<b>Well Name:</b> POKER LAKE CVX JV PB	<b>Well Location:</b> T26S / R31E / SEC 4 / SESW / 32.0655762 / -103.7847659	<b>County or Parish/State:</b> EDDY / NM
<b>Well Number:</b> 3H	<b>Type of Well:</b> OIL WELL	<b>Allottee or Tribe Name:</b>
<b>Lease Number:</b> NMLC069514B	<b>Unit or CA Name:</b>	<b>Unit or CA Number:</b>
<b>US Well Number:</b> 3001539847	<b>Well Status:</b> Producing Oil Well	<b>Operator:</b> XTO PERMIAN OPERATING LLC

### Notice of Intent

**Type of Action:** Plug and Abandonment

PLUG AND ABANDON WELLBORE  
POKER LAKE CVX JV PB 003H  
EDDY COUNTY, NEW MEXICO  
Class II

# PL CVX JV PB 003H- Proposed WBD

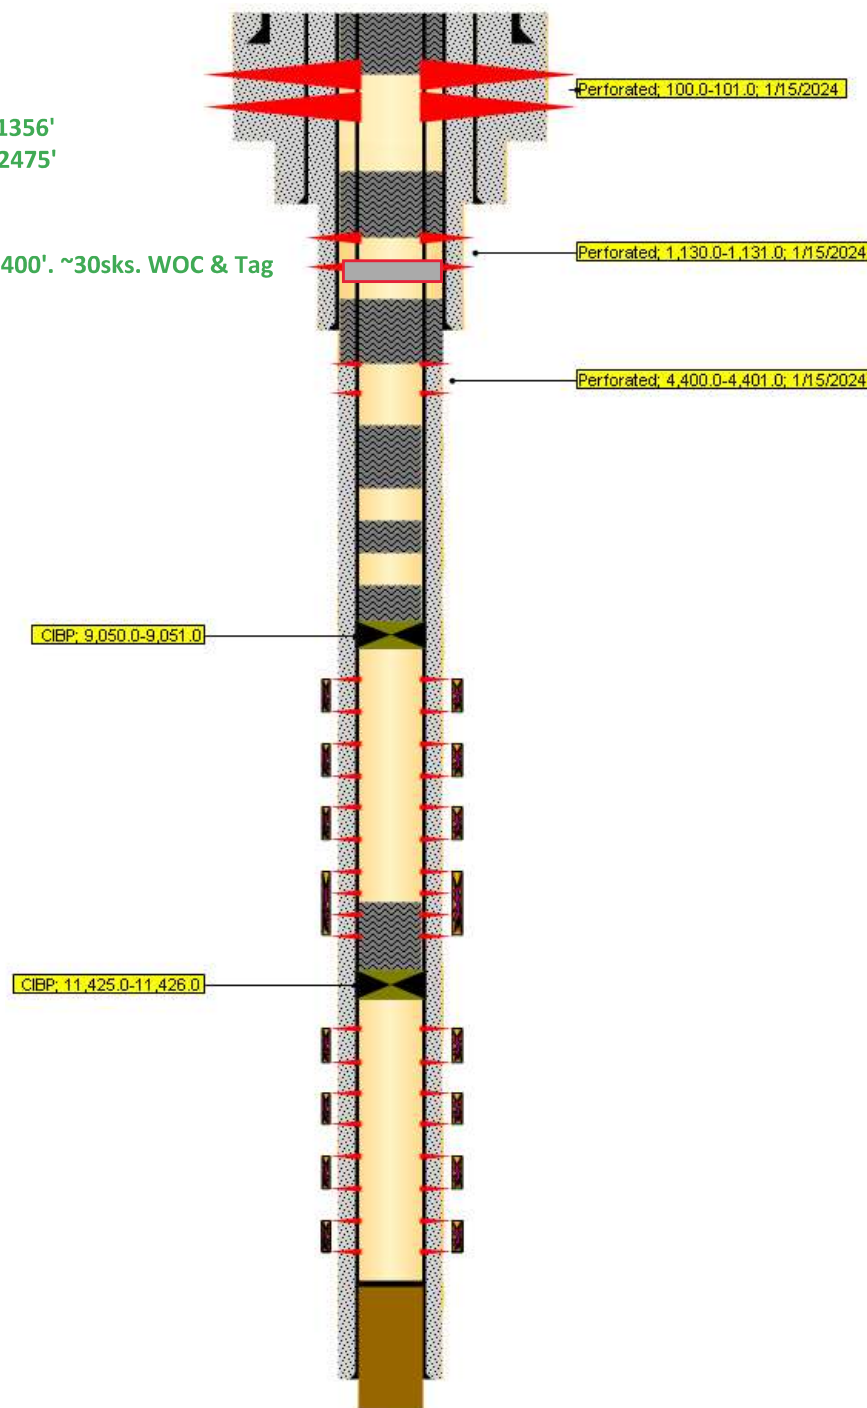
4400' TOC Perf & Sqz: 2525-2400'. ~30sks. WOC & Tag

Perf and squeeze 55-SKS Class C:  
1,130' to 975'. WOC and Tag.  
1,406'. Including TOS. ~100sks

No more than 2000' is to be allowed between plugs in open hole, and no more than 3000' between plugs in cased hole.
Class H >7500'
Class C<7500'
Fluid used to mix the cement in R111P shall be saturated with the salts common to the section penetrated, and in suitable proportions, but not more than 3% calcium chloride by weight of cement will be considered the desired mixture whenever possible.
Critical, High Cave Karst: Cave Karst depth to surface
R111P: Solid plug in all annuli - 50' from bottom of salt to surface.
